**FINAL DRAINAGE REPORT
ADDENDUM NO. 2
BENT GRASS RESIDENTIAL FILING NO. 1
FOR
BENT GRASS EAST COMMERCIAL
FILING NO. 3**

CCES Responses in red

PCD Filing No.: SP-20-010

BENT GRASS EAST COMMERCIAL FILING NO. 3 DEVELOPED DRAINAGE MAP			
DESIGNED BY	MAW	SCALE	DATE 10-27-20
DRAWN BY	MAW	(H) 1"= 30'	SHEET 1 OF 1
CHECKED BY		(V) 1"= N/A	JOB NO. 2177.64

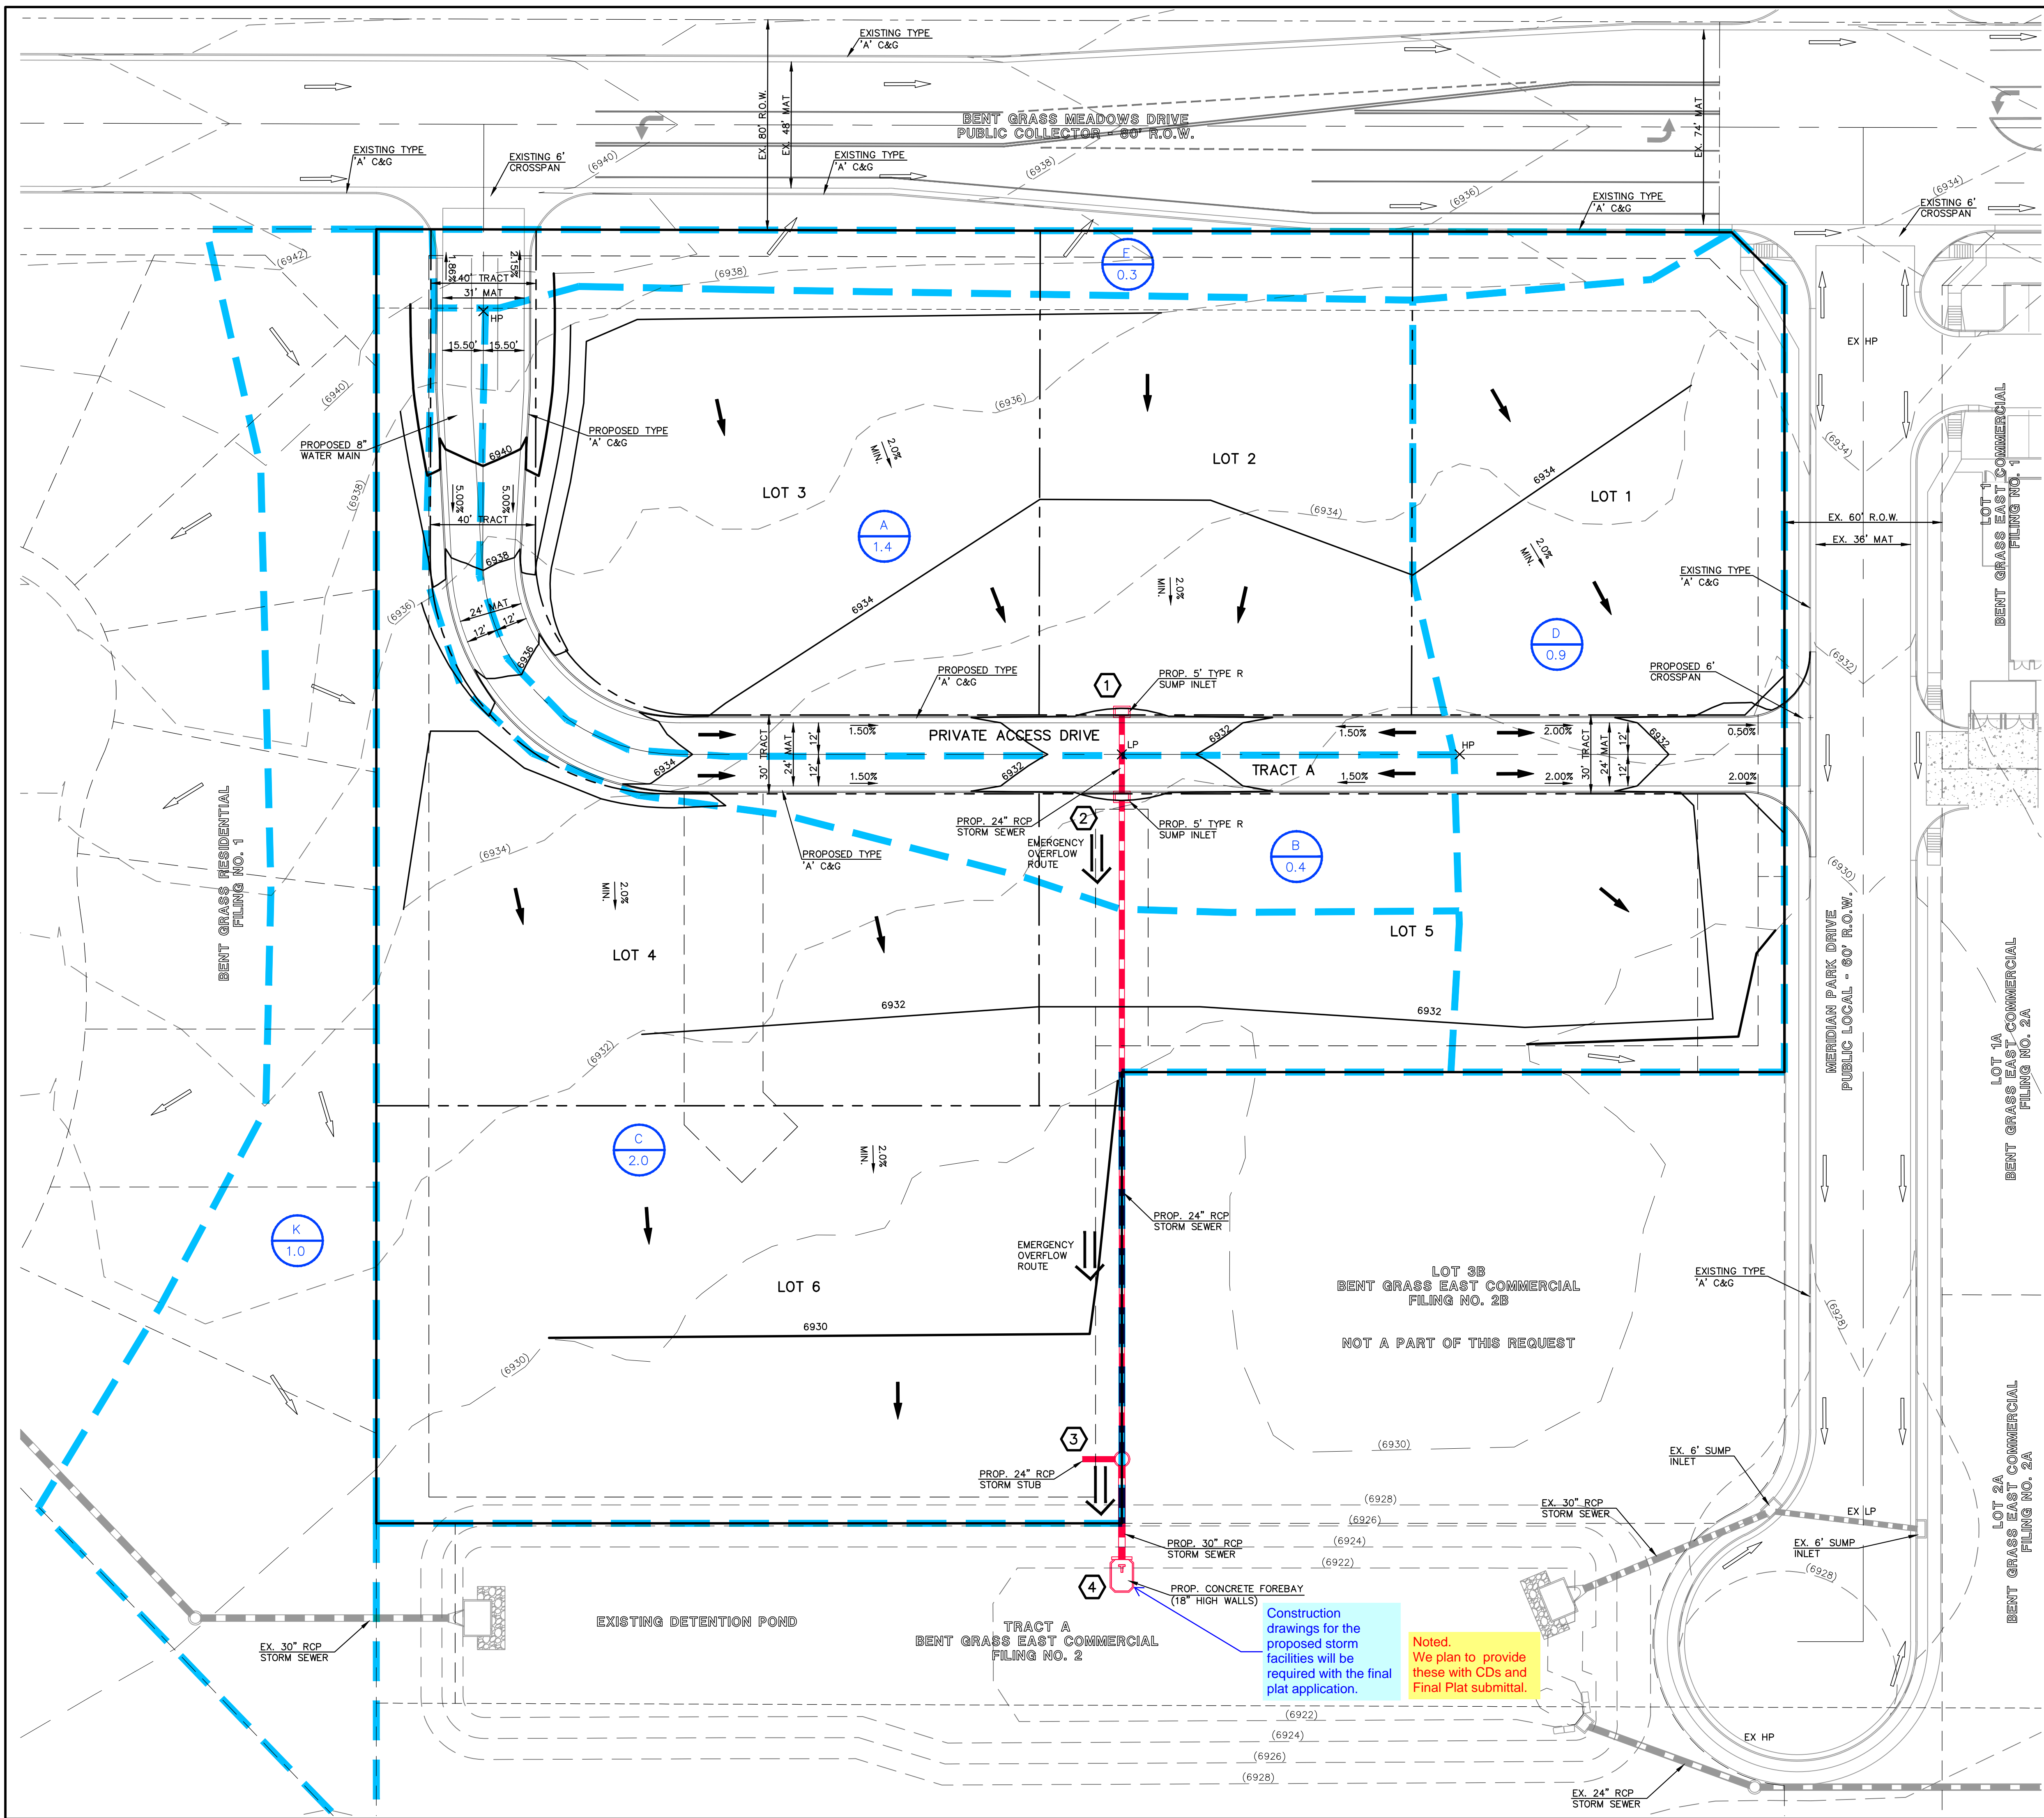
please provide a table with your
calculated basin/design point flows as
done with the previous drainage map in
the next page.

Construction
drawings for the
proposed storm
facilities will be
required with the final
plat application.

Added

Noted.
We plan to provide
these with CDs and
Final Plat submittal.
